# IMPORTANT UPDATE INFORMATION

Because of the change of the new coming CPU, some of the feature on this mainboard was modified. Please refer to the description in this document for the update:

SOCKET 370 IS REMOVED FROM THE MAINBOARD

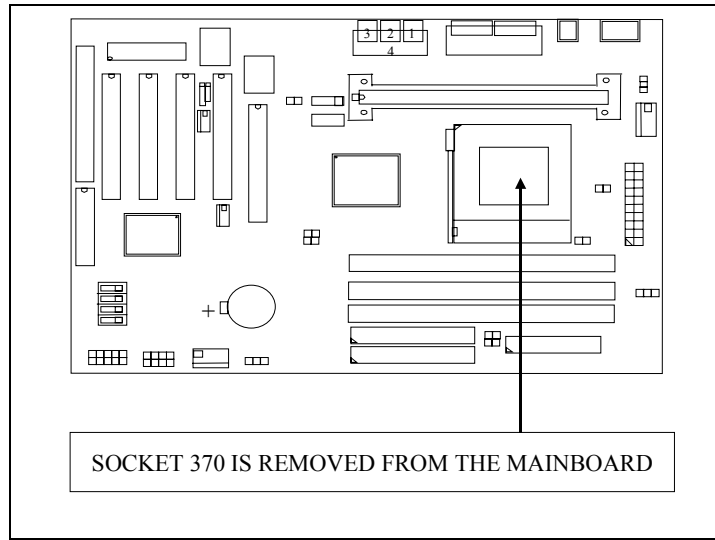
1. Intel is changing its CPU architecture and it will make the traditional socket 370 failed to work with the new CPU. So the socket 370 is removed from the mainboard.

JP100   JP133

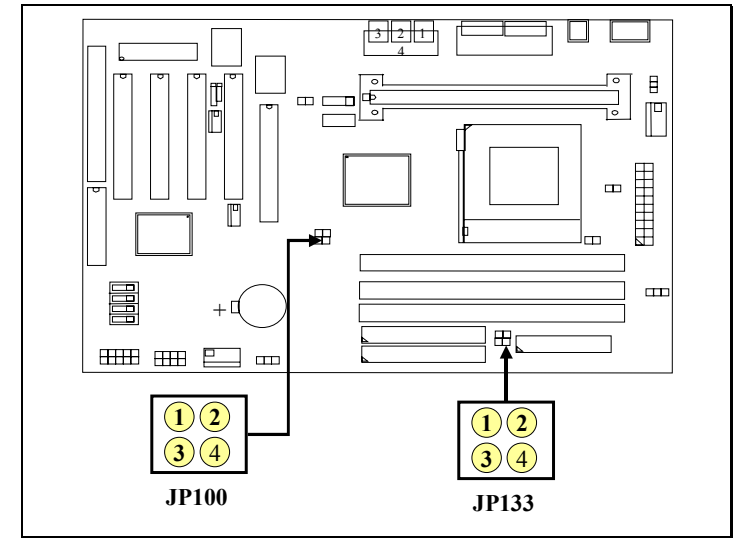
3. Because of the change of the CPU socket on the mainboard, the jumper settings of JP100 and JP100 is changed. Please refer to the following for the change.

The jumper setting of JP100 and JP133 is changed. Please refer to the following table for the updated jumper setting.

JP 100		JP133	
FSB CLOCK	Pin1 - Pin2	Pin3 - Pin4	Pin1 - Pin2	Pin3 - Pin4
Auto	Short	Open	Short	Open
66MHz	Open	Short	Open	Short
100MHz	Open	Open	Open	Short
133MHz	Open	Open	Open	Open
